#### Village of Royal Palm Beach Village Council Agenda Item Summary

Project Name: Tuttle Royale Pod 4 Site Plan

Application: 24-121 (SPM, AAR) (Res. No. 24-40)

Request: Major Site Plan Modification and Architectural Approval to remove

#### Attachment C Cont'd Site Plan Tuttle Royale Pod 4 Site Plan Application No. 24-121 (SPM, AAR) Resolution No. 24-40

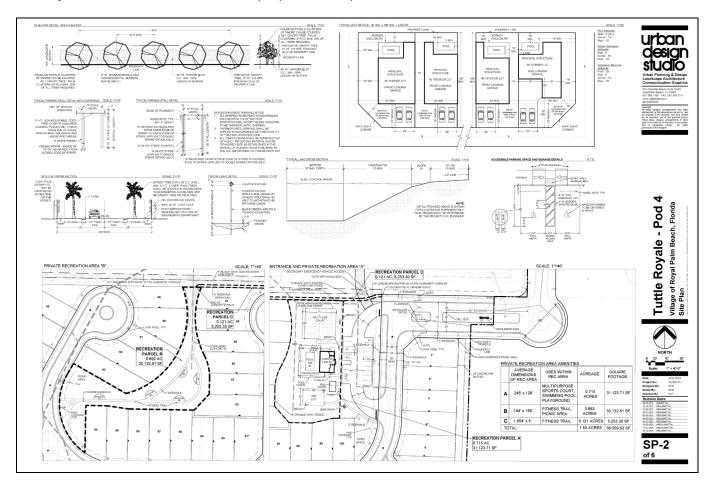
- Reorient Monument Sign at site's entry to east-west orientation, and match provided signage drawings provided in AAR request for Site Plan consistency.

- Remove entry guardhouse structure.
- Proposed flagpole near existing location of entry guardhouse structure.
- Propose entry gates & decorative post near existing location of entry guardhouse structure.

- Realign gates at vehicular entry of site to be in line with the center of the proposed entry decorative gates feature.
- Revise Amenity area layout.
- Redesign multi-use court.

- Add 12' chain-link fence surrounding multi-use court.
- Redesign Cabana from existing 1,400 SF Cabana to match provided 1,409 SF Cabana drawings provided in AAR request for Site Plan consistency.

- Redesign pool layout and add dimensions and paver label.
- Dimension mail kiosk at 12' x 20'.
- Add 6' black vinyl coated chain link fence along the northern subdivision perimeter, south of the FPL easement, west of the emergency access gate.

- Add decorative aluminum fence east of emergency access gate along northern site perimeter.
- Add ADA parking detail on Sheet SP-2.
- Add 6' concrete panel wall along rear of Lots 1-8.

- Add 20' emergency access path and gate with knox box.
- Revise 5' sidewalk detail north of lots 49 and 67 on Sheet SP-2 to depict 5' pervious sidewalk within 25' landscape buffer.

- Add 6' Opaque Vinyl fence on rear of lots 89-100.
- Revise location of 20' drainage easement to be correctly placed in between Lot 20 and Lot 21. Approved Plan depicted 20' Drainage Easement going directly through Lot 20, instead of in the area designated for the easement in between Lot 20 and Lot 21. The relocation of the drainage easement matched engineering and utility plans for the site as depicted in the proposed replat of Pod 4 of the Tuttle Royale Plat.

- Resize and revise location of 10' utility easement along the site's west perimeter to be correctly placed along the northern edge of Lot 41. Approved Plan depicted 12' utility easement going directly through the center of Lot 41. The relocation of the drainage easement matched engineering and utility plans for the site as depicted in the proposed replat of Pod 4 of the Tuttle Royale Plat.

- Revise location and size of Dry Detention within FPL Easement to reflect civil plans.
- Add flagpole detail on Sheet SP-3.
- Update Site Data for consistency.

- Add Cabana, Mail Kiosk, Entry Signage, Decorative Posts and Entry Gate details on SP sheets 3-5.
- Add LW-19-02 Landscape Waiver Chart to Site Plan.

- Reflect 20' Sewer Easement consistent with the approved configuration recorded in Plat Book 133, Page 101.
- Restrict lots 20, 21, 80, and 81 to be 2-story models only.

# Attachment D Landscape Plan Tuttle Royale Pod 4 Site Plan Application No. 24-121 (SPM, AAR) Resolution No. 24-40

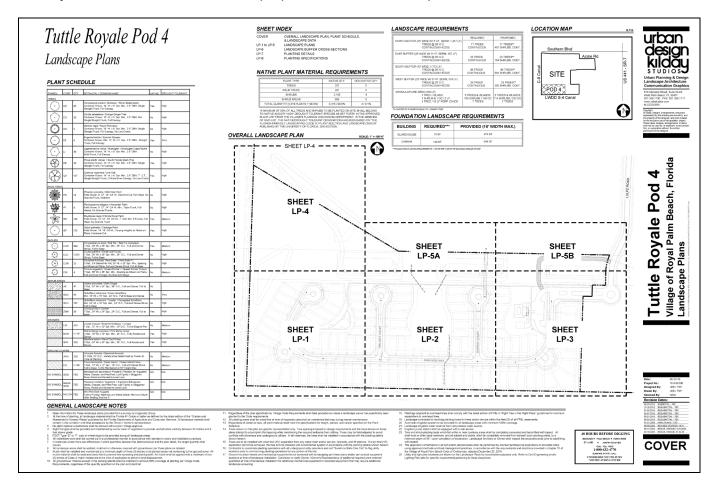
- Minor shifts in street Tree locations and provision of additional root barriers to street trees to meet all utility setback and root barrier requirements.

- Add 6' Black Vinyl coated Chain Link Fence along northern landscape buffer.
- Remove Date Palm in roundabout island in between lots 48 and 50 to avoid conflicts with storm drain which is routed through the island.

- Remove pervious label from 5' sidewalk proximate to lots 49,50,65,66, and 67.
- Reduce Green Island Ficus Quantity and remove Coontie shrub on east side of roundabout island proximate to Lot 69 in order to avoid conflicts with storm drain routing.

- Add 6' concrete panel wall along rear of Lots 1-8.
- Add 20' emergency access path.
- Add decorative aluminum fence east of emergency access gate along northern site perimeter.

- Add 6' Opaque Vinyl fence on rear of lots 89-100.
- Revise Root Barrier Detail.
- Revise entry landscape island per removal of approved guardhouse and reorientation of entry monument signage.

- Enhance landscape screening material in rears of lots 89-100 adjacent to recreational area.
- Update Plant Schedule specifications to depict 2.5" DBH minimum.

- Reflect 20' Sewer Easement consistent with the approved configuration recorded in Plat Book 133, Page 101.

- F. The landscape plan shall be revised and resubmitted to the Village to ensure that all landscaping is located outside of all easements prior to the issuance of a building permit.
